UNITED STATES  
NUCLEAR REGULATORY COMMISSION  
WASHINGTON, D. C. 20555

Docket No.: 50-412

APPLICANT: Duquesne Light Company (DLC)  
FACILITY: Beaver Valley Power Station, Unit 2  
SUBJECT: GEOSCIENCE BRANCH (GSB) MEETING SUMMARY

Site Dependent Response Spectra  
Beaver Valley Power Station - Unit No. 2

FIGURE 3-4  
 SITE MATCHED RESPONSE  
 SPECTRUM ADJUSTED FOR SHEAR  
 WAVE VELOCITY CONTRAST  
 BEAVER VALLEY POWER STATION - UNIT 2  
 STONE & WEBSTER ENGINEERING CORPORATION

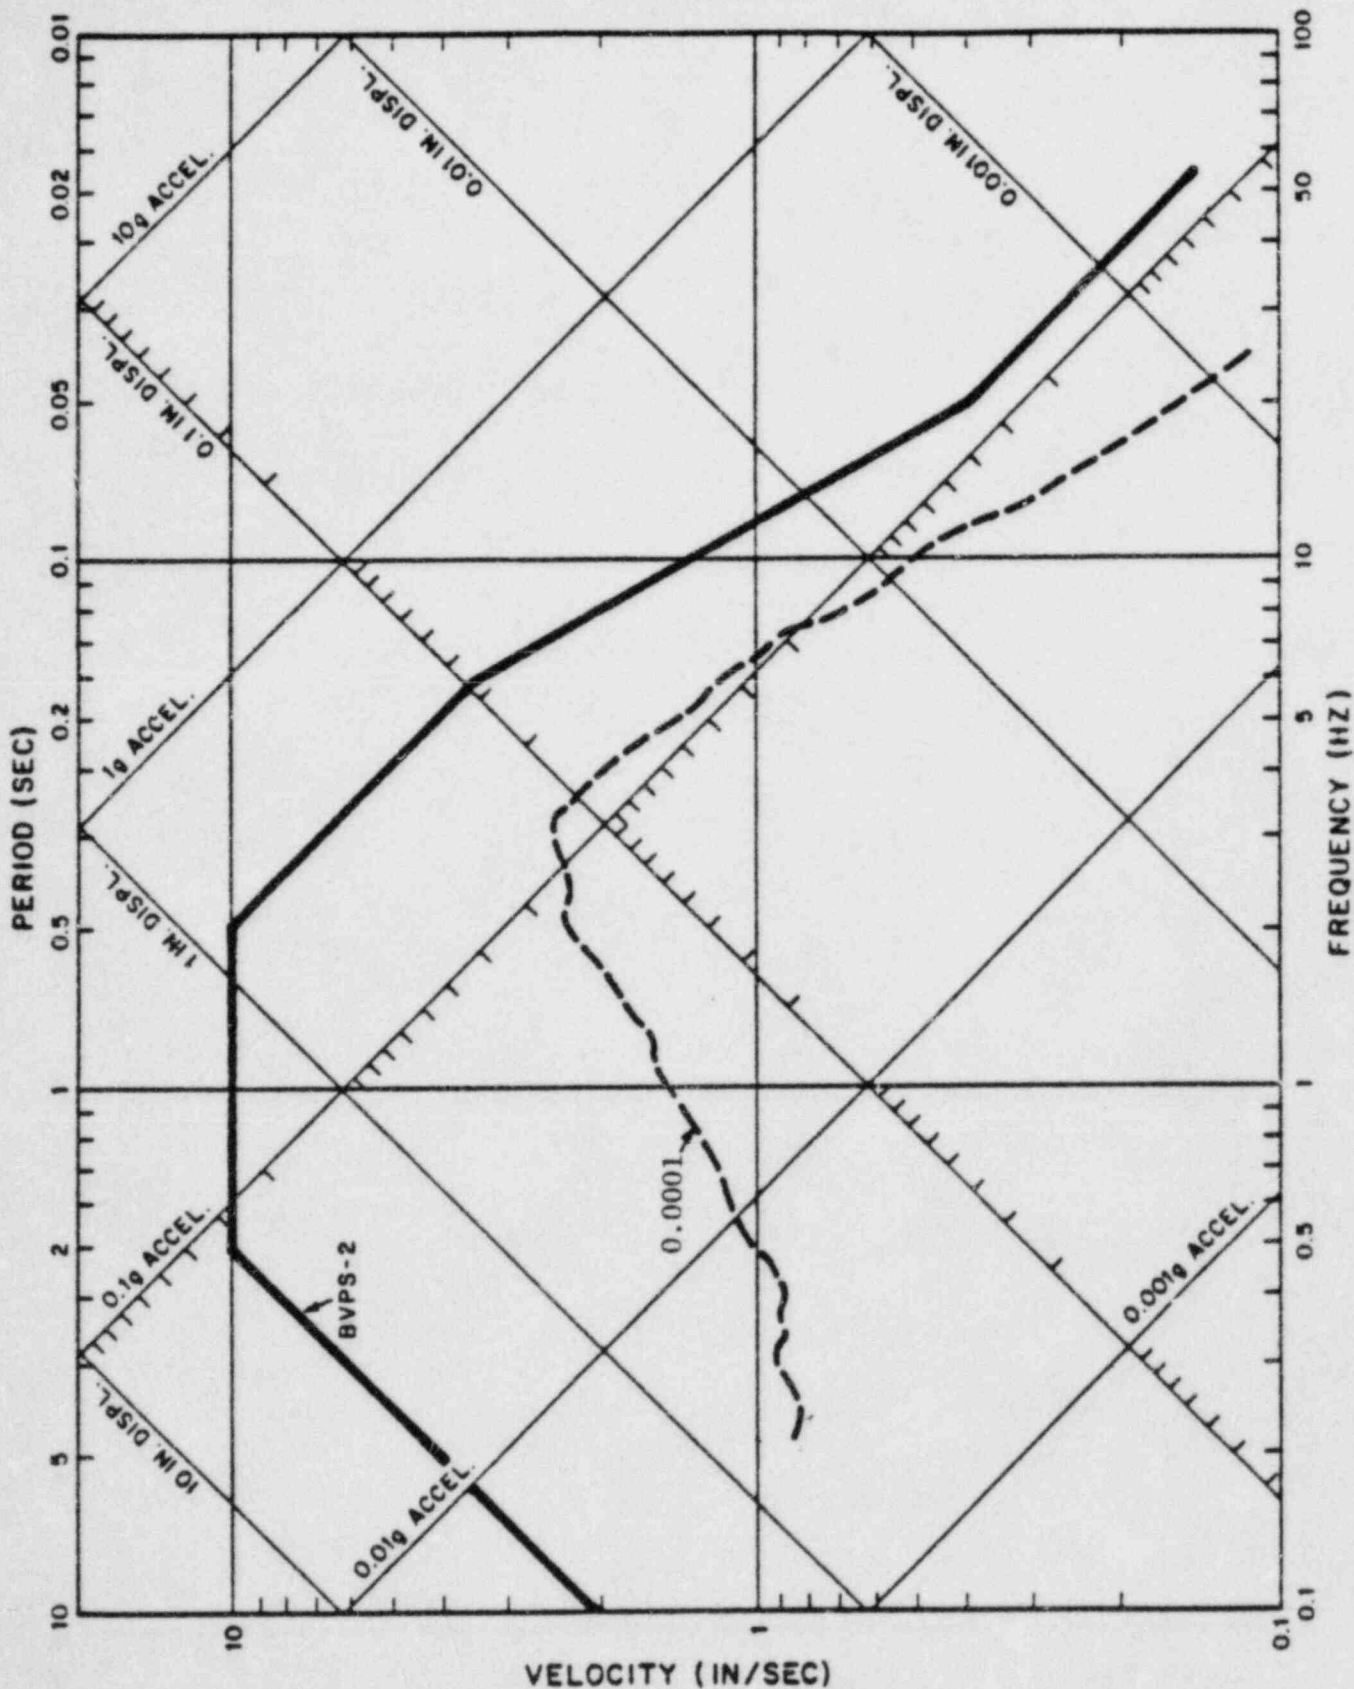
The results show that the site specific spectrum (SSS) obtained for an expanded suite of rock records amplified through a soil profile (SHAKE) exhibits significantly higher acceleration values than a site matched SSS for a site of soil based sections even when this spectrum is boosted by 10% to allow for the higher velocity contrast at rock interface (3000 ft/sec r.s. 5000 ft/sec).

2. Calculate both the site matched and soil amplified 84th percentile SSS.
3. Do an analysis of the "C" shelter record from the Franklin - Falls Dam (New Hampshire earthquake record) and compare it to the site matched site specific spectrum.
4. Use the Alexander Building record to verify the SHAKE analysis which resulted in a 10% difference between 3000 ft/sec and 5000 ft/sec rock velocity at interface with soil column.

FIGURE 4-3  
 HORIZONTAL RESPONSE SPECTRUM  
 FROM SOIL RESPONSE  
 ANALYSIS: OUTPUT SCALED  
 BEAVER VALLEY POWER STATION-UNIT 2  
 STONE & WEBSTER ENGINEERING CORPORATION

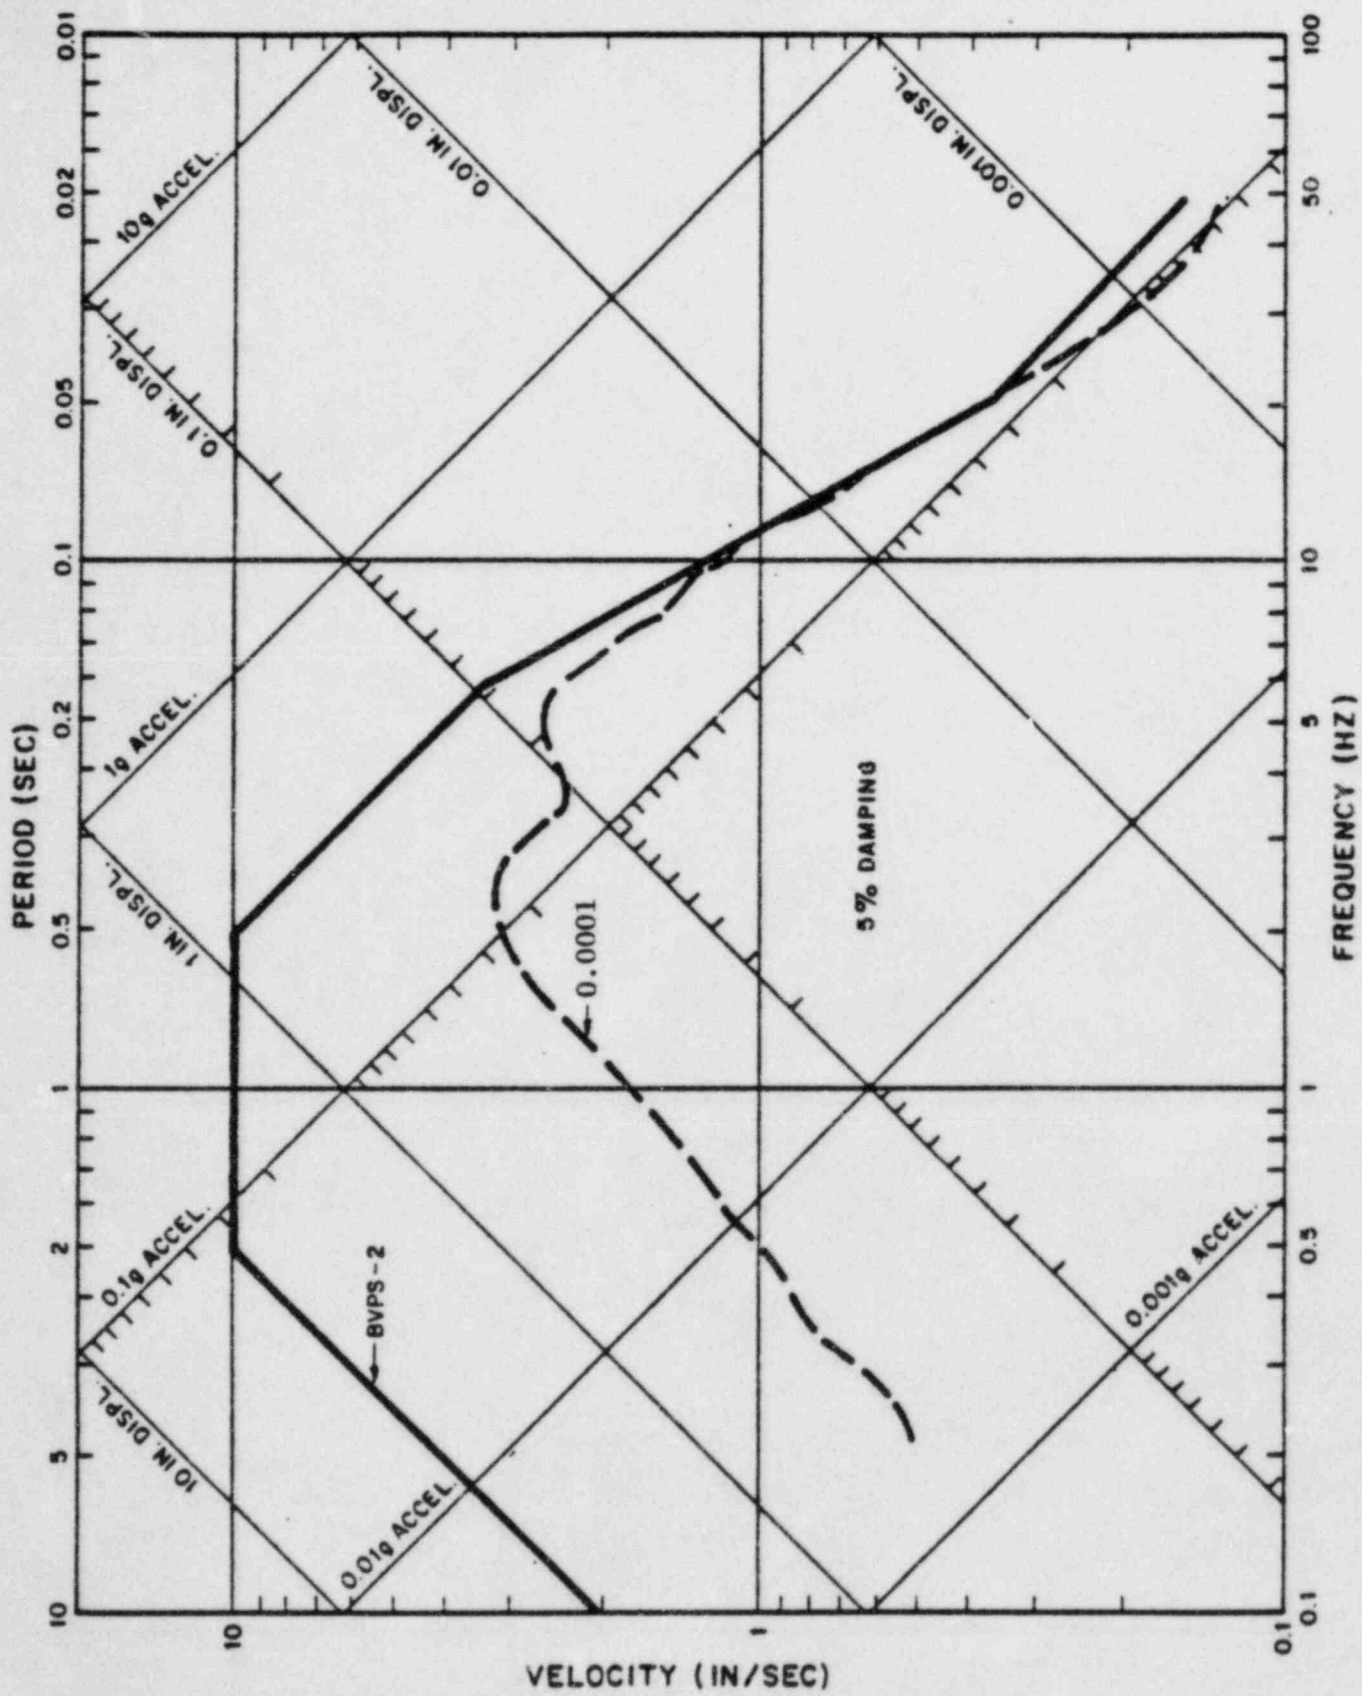
The 84th percentile of the "soil response" SSS is definitely going to exceed the BVPS design spectrum. However the NRC staff insisted on the applicant showing the 84th percentile SSS since that has become the accepted procedure in the use of SSS.

1. Calculate the SSS at the foundation of the critical structures by using a statistical rock spectra amplified through a BVPS site soil column up to the same elevation as the foundations of the structures.
